DRI 674 M5 Stone Bank Development

- Taqueria Drawings
- Fire Feature
- Addition
- Chimney/Fireplace Proposal
- New Master Deed (square footage changes)
- Carport

AWNING DETAILS

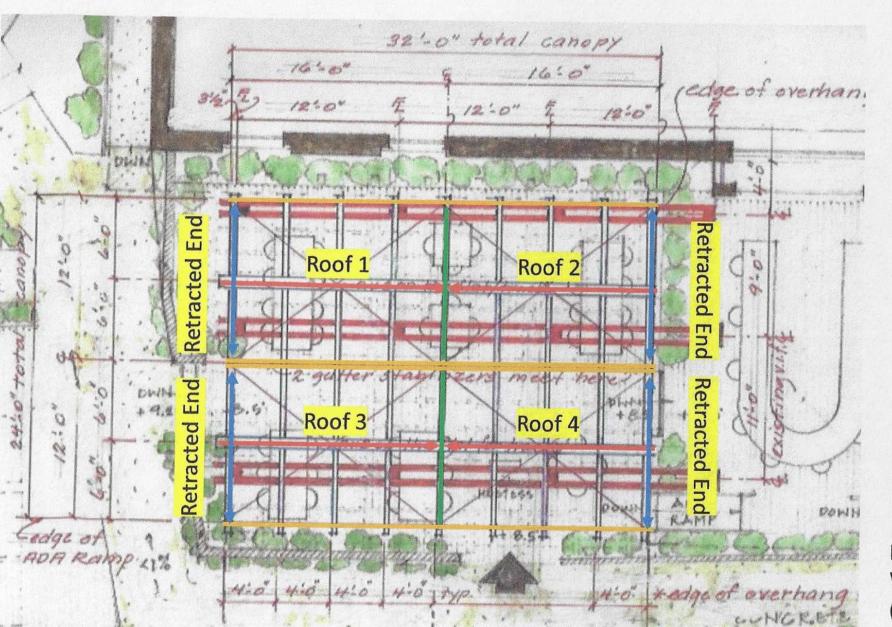
Water to drain out which end & How? (A) Open Slot

Chimneys & Fireplaces Proposal Following September 7, 2023 Denial

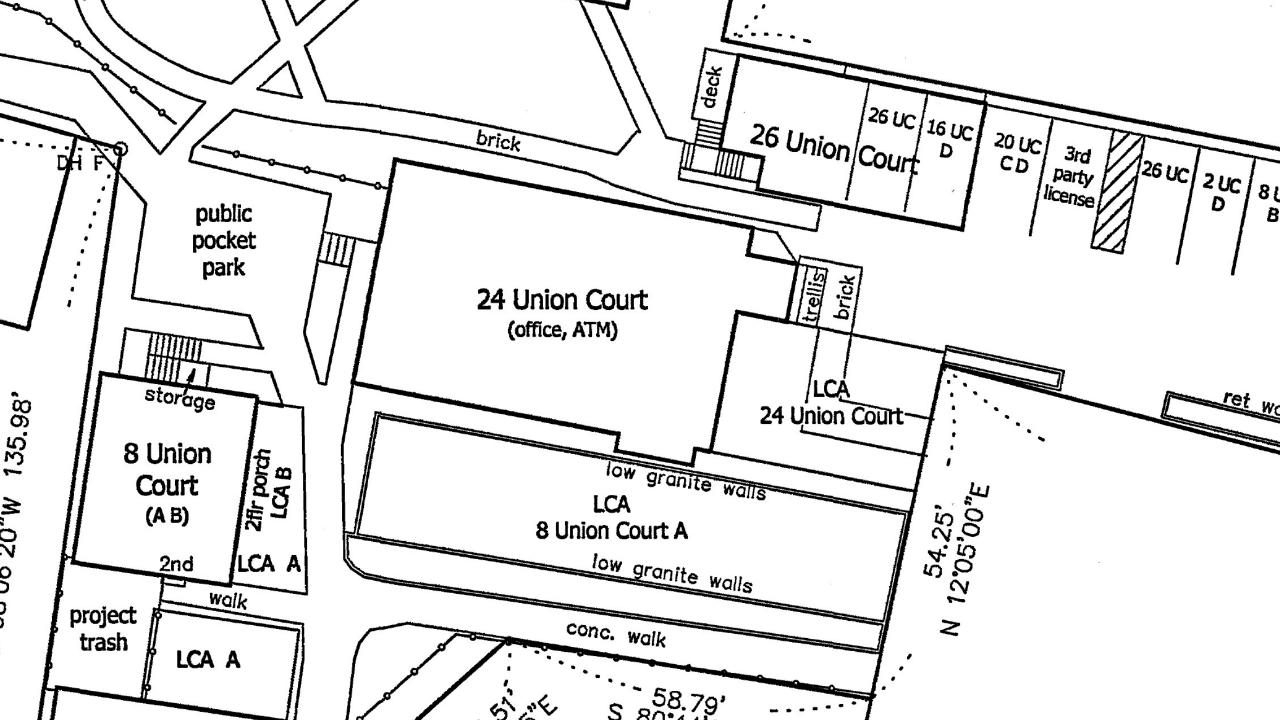
"I am proposing to install three gas fireplaces in the project in exchange for:"

- Using all-electric cooking instead of gas in three residential units. (R-5, R-10 and R-11)
- Using electric ovens instead of gas in four residential units. (R-4, R-7, R-8, and R-12)
- Using electric hot water instead of gas in two residential units (R-10 and R-11)
- Using electric hot water instead of gas in five commercial units (C-2, C-4, C-5, O-5 and O-1)
